ET-5207-510A or ET-30D (7520751000)
(pcb 2291032804 or 052-288D)

ET-30B (151-030B)

MODIFICATION FOR CONTINUOUS LED LIGHTING

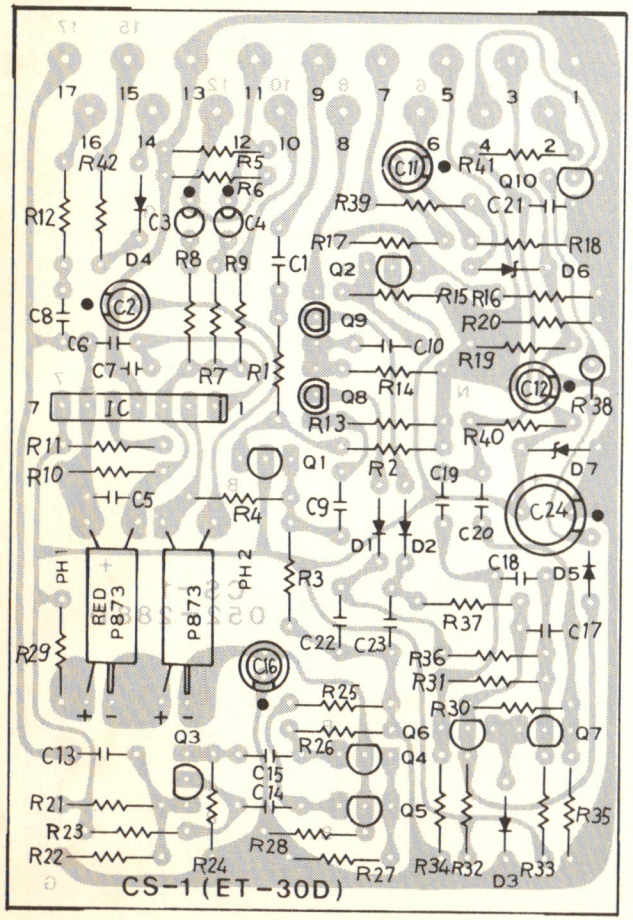
LED connected to ET-30B is not lit during Effect mode. The following steps will cure the problem but also encourages higher current being drawn. Lower-power consumption LED SLP-135B is incorporated in the later versions.

When replacing LEDs, increase R39 resistance to 3.9k.

1. Re-route LED blue lead to Q7 collector (at foil side).
2. Replace C21, 1/50 or 0.47/50, with 0.01 mylar.
3. Replace C19 and C20, 470pF, with 220pF for stable flip-flop performance at lower supply voltages. (6-7V)

AC ADAPTOR JACK

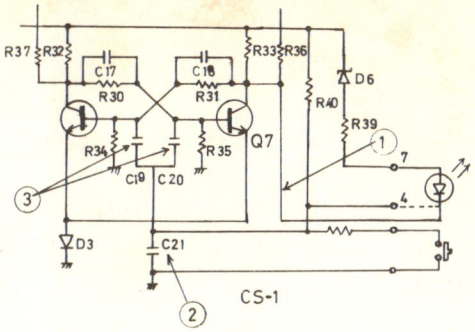
Changed to HEC-0317 for positive plug connection, involving re-design on case's mounting hole. The new, incompatible with the old, can be replaced by the old.
